Smart Motorways Programme

M4 J3 – J12

Package 1 (J8/9 to J12) Designer's Response to Road
Safety Audit (Stage 2)

Document Number: HA514451-CHHJ-GEN-S1_ZZZZZZZZ_Z-RP-ZZ-0004

Extract from drawing HA514451-HGN-S1_ML000000_Z-DR-CH-1019 Rev C02

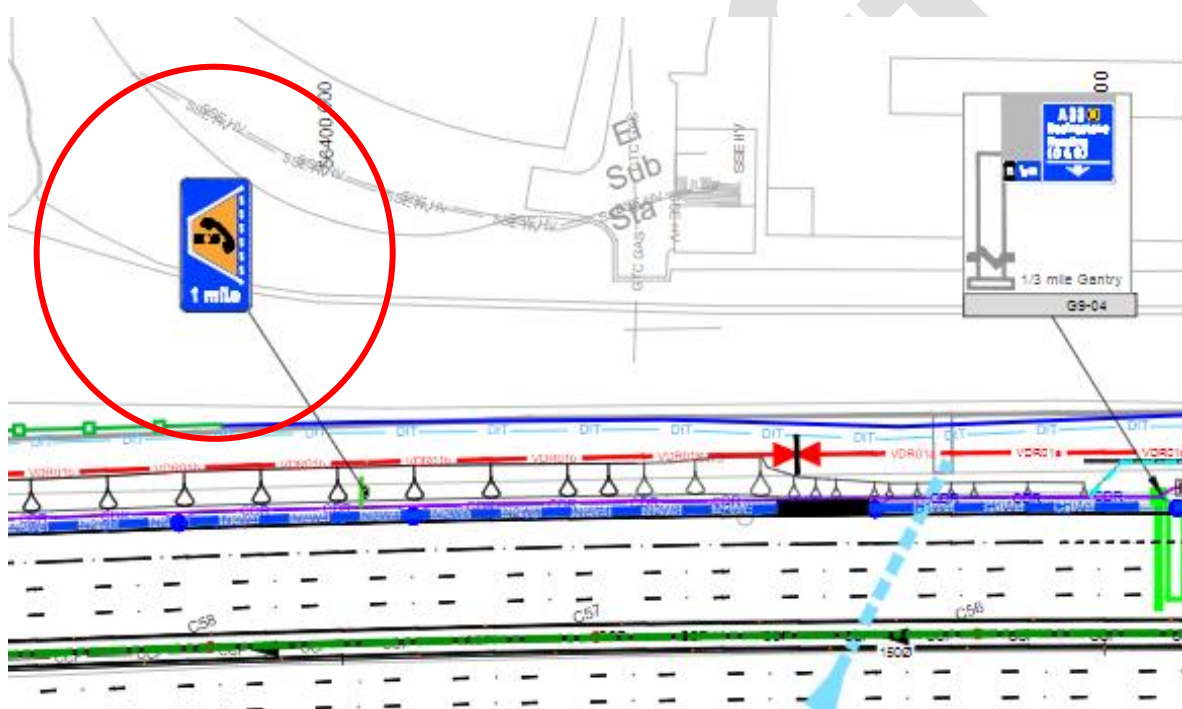
Location: Eastbound EA sign PS-B-67/3_50 (Drawing HA514451-HGN-S1_ML000000_Z-DR-CH-1019 Rev C02 Sheet 19 of 91) M4 westbound (chainage 556400)

Summary: EA sign provided does not correlate with an EA and may result in motorists traveling further to seek assistance

The eastbound 1 mile EA sign PS-B-67/3_50 provided at chainage 56400 does not correlate with an EA, as the next mainline EA is 2.2 miles/3.6km to the east. If the sign is intended to reference a place of relative safety at junction 11, it is not clear where this is and that drivers would have to leave the mainline carriageway. The use of an EA sign with orange colouring could also be misleading.

Recommendation

It is recommended that the referenced EA is clarified and the sign removed or replaced accordingly. If the sign is referencing a place of relative safety additional signing should be provided to advise drivers, such as 'follow junction 11 for emergency telephone/layby', or that hard shoulder is available intra junction at junction 11.

Designer accepts the RSA problem and recommendation made by the RSA team.

This sign should be removed as it is for the legacy ERA underneath J11 that was removed during the VE process and change to NTJR.

Extract from drawing HA514451-HGN-S1_ML000000_Z-DR-CH-1034 Rev C02

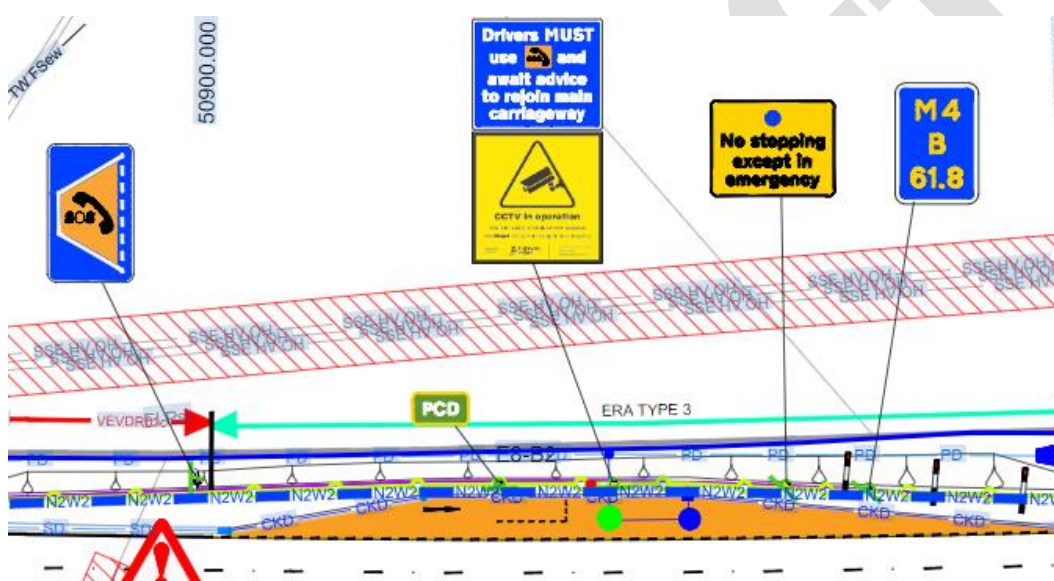
Location: EA E8-B2 (Drawing HA514451-CHHJ-HGN-S1_ML000000_Z-DR-CH-1034 Rev C02 Sheet 34 of 91) M4 eastbound (chainage 50850)

DESIGNERS RESPONSE: Exception

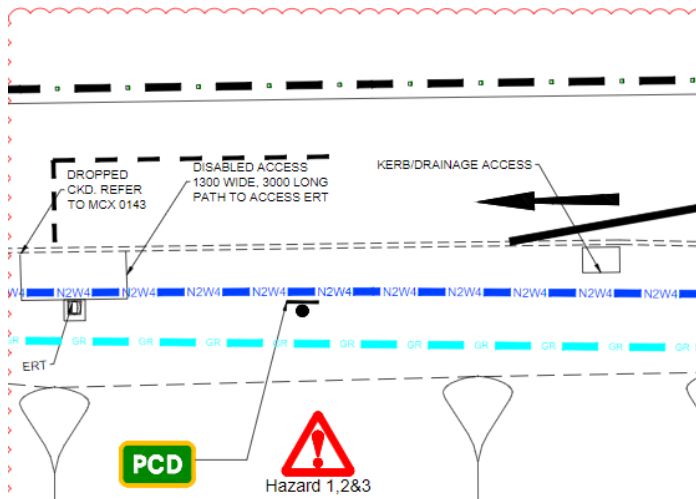
Location: EA E7-B4 (Drawing HA514451-CHHJ-HGN-S1_ML000000_Z-DR-CH-1055 Rev C02 Sheet 55 of 91) M4 eastbound (chainage 43300)

Pedestrian Restraint will be extended to provide protection along entire EA E7-B4 length.

Pedestrian restraint has been located outside the working width of road restraint system, as shown on the Verge Details throughout Contract 1. 400 Series Specification will also detail instruction to locate pedestrian guardrail outside working width of the vehicle road restraint.

Extract from drawing HSN-S1_ZZZZZZZ_Z-DR-CH-12040 Revision C04

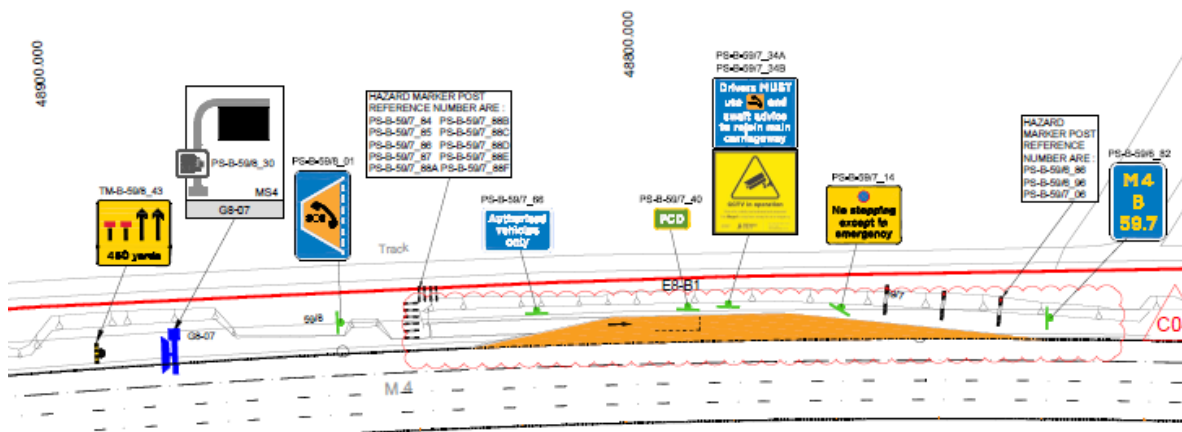
3.1.29 PROBLEM

DESIGNERS RESPONSE: Designer accepts the RSA problem and recommendation made by the RSA team.

Extract from drawing HKF-S1_ZZ000000_Z-DR-CH-11044 Revision C2

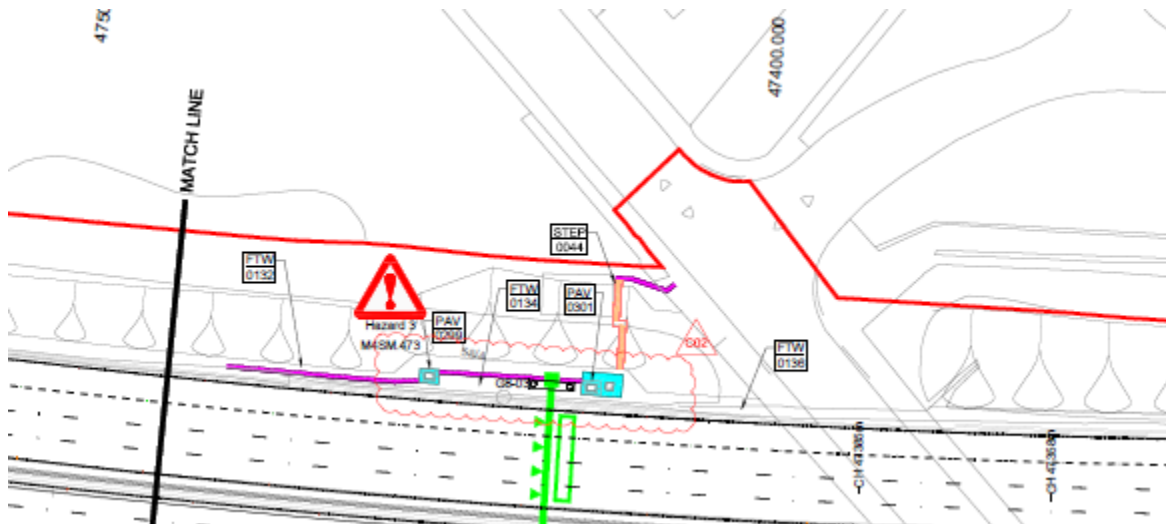
Location: Reading Road (Drawing HKF-S1_ZZ000000_Z-DR-CH-11044 Rev C02 Sheet 44 of 91) M4 eastbound (chainage 47420)

The kerbs and footways drawings detail a new maintenance access to the M4 carriageway, via a footway and access steps, at chainage 47420. It is unclear how the access will interact with the existing Reading Road footway and the post and rail fence. The direct, paved access to the M4 at this location could result in unauthorised use of the access and increase the potential for pedestrians to be alongside or within the M4 carriageway. In turn this increases the potential for collisions involving pedestrians.

DESIGNERS RESPONSE: Designer accepts the RSA problem and recommendation made by the RSA team.

There is a gate proposed in the post and rail boundary fence (shown in drawing HA514451-CHHJ-HFE-S1_ZZ000000_Z-DR-CH-3044), separating the Reading Road footway with the Highways maintenance access. The gate is labelled suitably to deter pedestrians from accessing the maintenance footpath.

Extract from drawing HPV-S1_ML000000_Z-DR-CH-0747 Revision C01

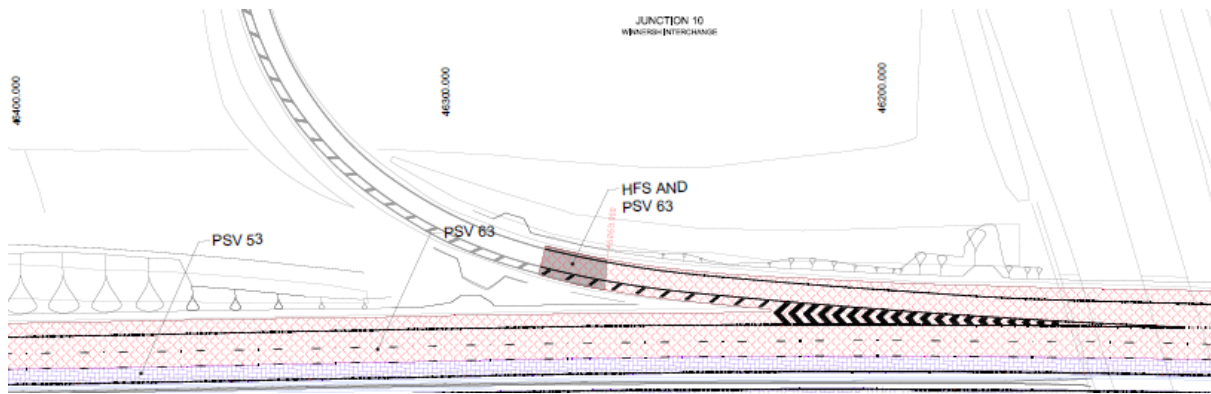
Location: Various merge and diverge slip roads

Exception

We have been instructed no pavement work should be undertaken beyond highway alignment.

Extract from drawing HA514451-HGN-S1_ML000000_Z-DR-CH-1024 Rev C03

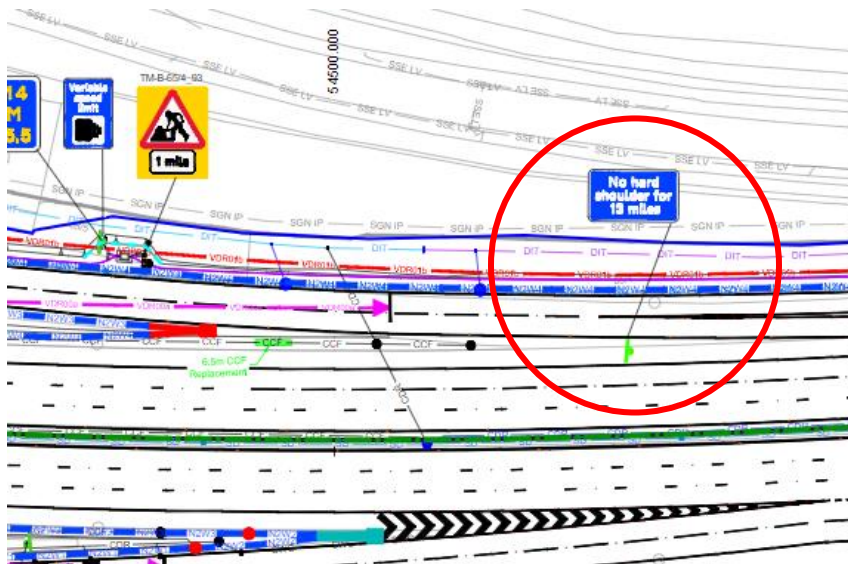
Summary: Signs located in front of the RRS or in gaps in the RRS

A number of signs are located in front of the RRS or in gaps in the RRS provision. It is unclear from the information provided whether the signs and post arrangements are passively safe. Examples include:

The 2D drawings provide indicative locations of signs to confirm chainage and orientation rather than offsets from edge of carriageway.

Extract from drawing showing G7-32 (chainage 44900),

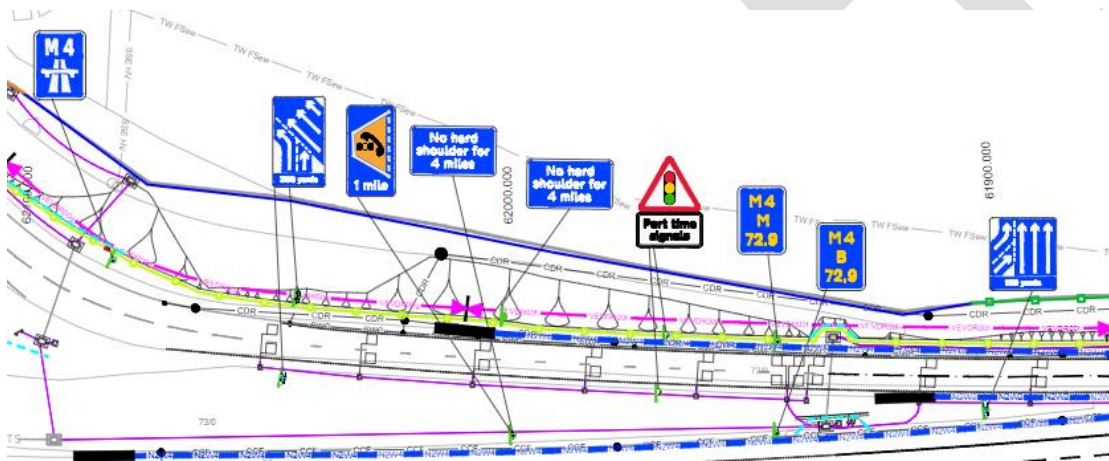
The plans provided show gantries that appear not to extend across the whole carriageway while including signs relevant to the offside lane (LBS4 4). This includes but is not limited to eastbound gantries G7-32 (chainage 44900), G7-31 (chainage 44750) and G7-23 (chainage 41750) and westbound gantries G7-21 (chainage 41100), G7-22 (chainage 53600) and G7-31 (chainage 44750). This could result in driver confusion, particularly with regards to 'red-x' emergency lane closures and lane designation, increasing the risk of secondary and lane change collisions.

It is recommended that all gantries cover the full carriageway width, with signs aligned over the centre of each running lane.

Designers recognise the issue raised by the auditors. The 2D layout plans are only indicative to confirm chainage and orientation.

Extract from drawing HA514451-HGN-S1_ML000000_Z-DR-CH-1005 Rev C02

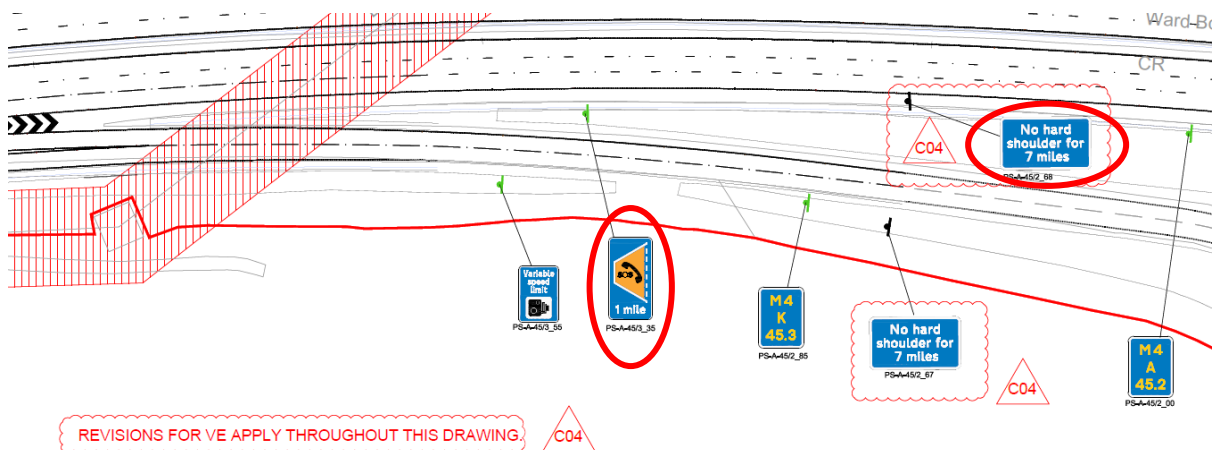
Location: Various – scheme wide

Mounting heights of all signs are included in the sign schedules which should identify that signs are mounted above the environmental barriers and other fencing.

Signs have been positioned in the best available locations based on the number of other signs, distance between junctions, other street furniture and to provide as much visibility as possible.

Furthermore, mounting heights of all signs have been checked and visibility checks have been undertaken to ensure that signs are not obscured.

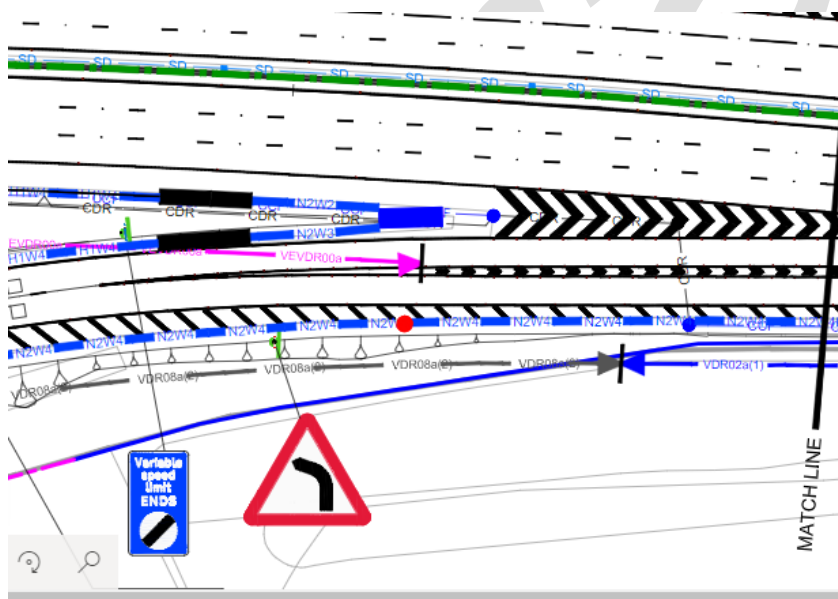
Location: Junction 10 eastbound diverge (Drawing HSN-S1_ZZZZZZZZ_Z-DR-CH-12046 Rev C04 Sheet 46 of 91 chainage 46700)

Designer accepts the RSA problem but suggests an alternative solution.

Would the audit team accept the removal of the offside bend warning sign. There is no requirement to have both signs under TSM Chapter 4.

Extract from drawing HA514451-HGN-S1_ML000000_Z-DR-CH-1049 Rev C02

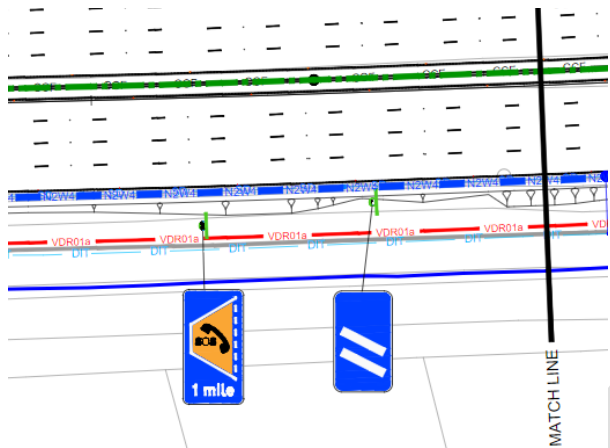
Location: Junction 8/9 east and westbound diverge (Drawing HSN-S1_ZZZZZZZZ_Z-DR-CH-12081 Rev C04 Sheet 81 of 91 chainage 33900) and junction 10 westbound diverge (Drawing HSN-S1_ZZZZZZZZ_Z-DR-CH-12049 Rev C04 Sheet 49 of 91 chainage 45400)

DESIGNERS RESPONSE: Exception

Designer disagrees with the safety auditor's recommendation. At the location of the VMSL end signs, the verge width is approximately 12m. It is considered that the sign shall also be at a considerable level difference and downstream enough of the mainline that the designers do not think these signs would be misinterpreted by mainline drivers. At Junction 10, the sign would not be visible if located on the nearside due to the bend warning sign. Contractors to ensure that the orientation of the signs is towards the slip roads.

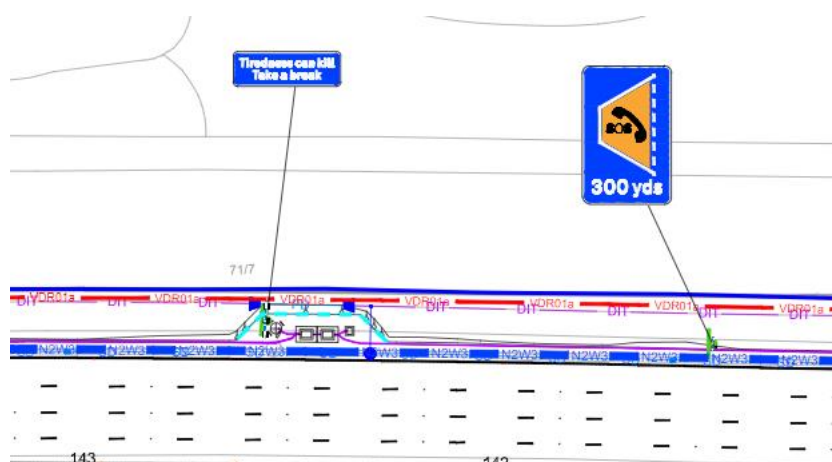
Location: Junction 12 westbound diverge (Drawing HA514451-CHHJ-HSN-S1_ZZZZZZZZ_Z-DR-CH-12003 Rev C04 Sheet 3 of 91)

It is recommended that sufficient carriageway markings and lane destination signage is provided to inform motorists of the road layout ahead.

Designer accepts the RSA problem raised, but suggests an alternative solution. The westbound diverge nose at Junction 12 is the end of the scheme extents for new road markings and new signing. There is an existing map type ADS being retained on the approach to the roundabout and a pair of existing left turn arrows in lanes 1 and 2 to confirm that these are left turn only lanes. This is an existing issue that is unaffected by the scheme proposals.

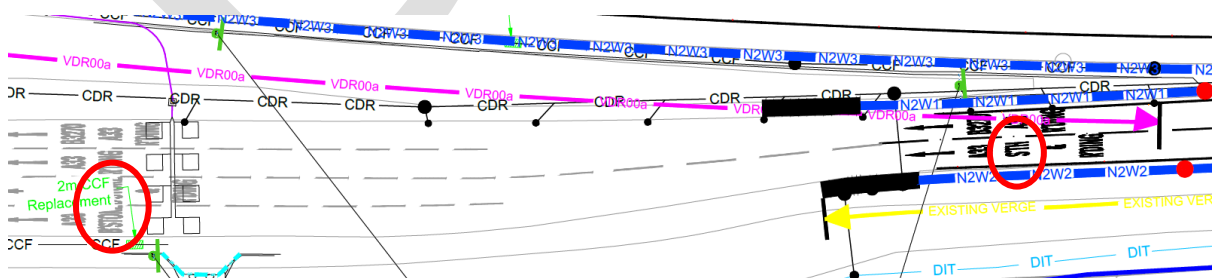
Location: Eastbound M4 mainline at chainage 39300 (Drawing No. HA514451-CHHJ-HSN-S1_ZZZZZZZ_Z-DR-CH-12066 Rev C04)

Designer accepts the RSA problem and recommendation made by the RSA team.

Designers suggest amending existing road marking to ensure that the lane drop leads in to both lanes 1 and 2 on the slip road rather than just lane 1.

Extract from drawing HGN-S1_ML000000_Z-DR-CH-1024 Revision C03

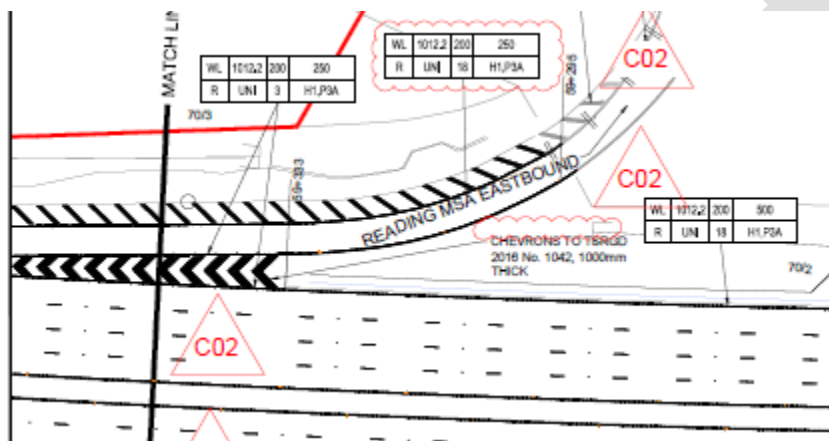
Location: Junction 11 westbound diverge chainage 54500 (Drawing HA514451-CHHJ-HGN-S1_ML000000_Z-DR-CH-1024 Rev C03 Sheet 24 of 91)

It is recommended that the carriageway markings in lane one of the two lane diverge are revised to include reference to Basingstoke, which provides consistency between the approach signage and existing markings on the diverge.

Designer accepts the RSA problem and recommendation made by the RSA team.

Existing road markings in lane one of the two lane diverge reads 'A33 S'TH & R'DING'. Proposed road markings have been designed to replicate existing road markings. However, the designer agrees that for consistency the markings should say 'A33 B'STOKE & R'DING'.

Extract from drawing HMK-S1_ML000000_Z-DR-CH-1211 Revision C02

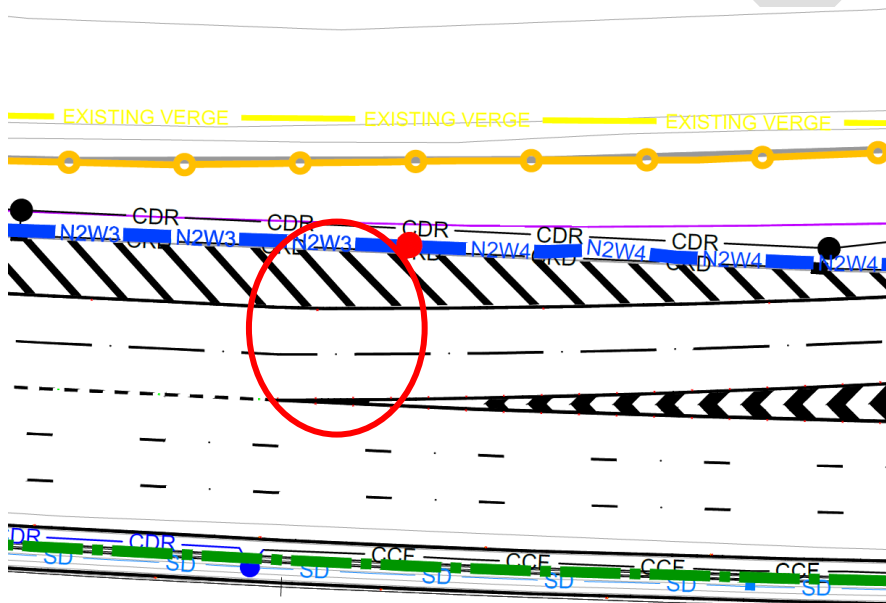
Location: Reading MSA chainage 52900 (Drawing HA514451-CHHJ-HMK-S1_ML000000_Z-DR-CH-1211 Rev C02 Sheet 11 of 91)

It is recommended that 'SLOW' carriageway markings to TSRGD Diagram 1024 are provided on the diverge lanes to the Reading MSA.

Designers agree that the diverges would benefit from the reinstatement of the 'SLOW' markings.

Extract from drawing HGN-S1_ML0000000_Z-DR-CH-1022 Rev C03

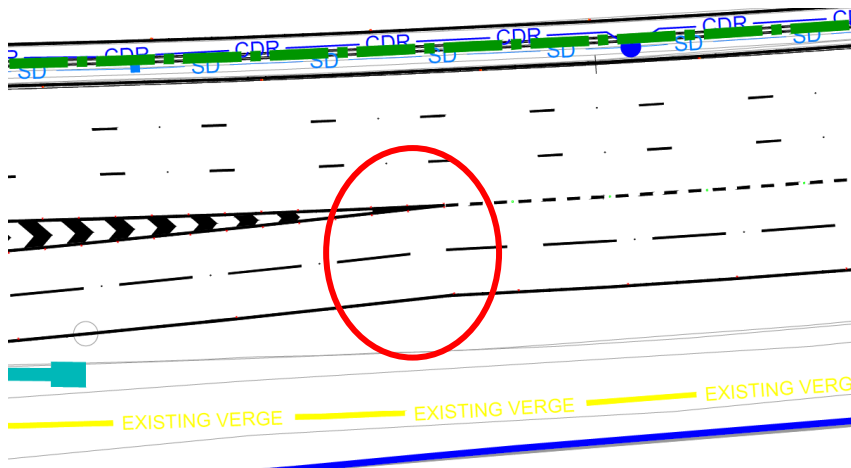
Location: Junction 11 eastbound diverge (Drawing HGN-S1_ML0000000_Z-DR-CH-1022 Rev C03 Sheet 22 of 91) chainage 55300

Ensure that the warning markings provide a smooth left-hand bend transition.

Designer accepts the RSA problem and recommendation made by the RSA team.

This appears to be a very minor drawing/ PDF presentation issue. The laid road markings shall be smooth and tie in correctly.

Extract from drawing HGN-S1_ML0000000_Z-DR-CH-1024 Rev C03

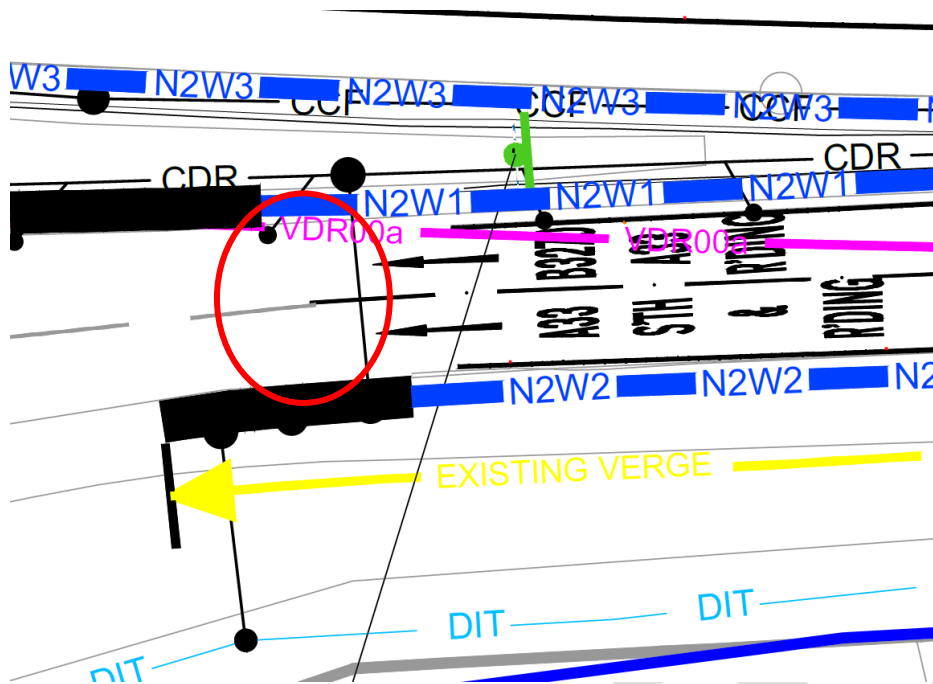
Location: Junction 11 westbound diverge (Drawing HGN-S1_ML0000000_Z-DR-CH-1024 Rev C03 Sheet 24 of 91) chainage 54400

Ensure that the warning markings provide a smooth left-hand bend transition.

Designer accepts the RSA problem and recommendation made by the RSA team.

This appears to be a very minor drawing/ PDF presentation issue. The laid road markings shall be smooth and tie in correctly.
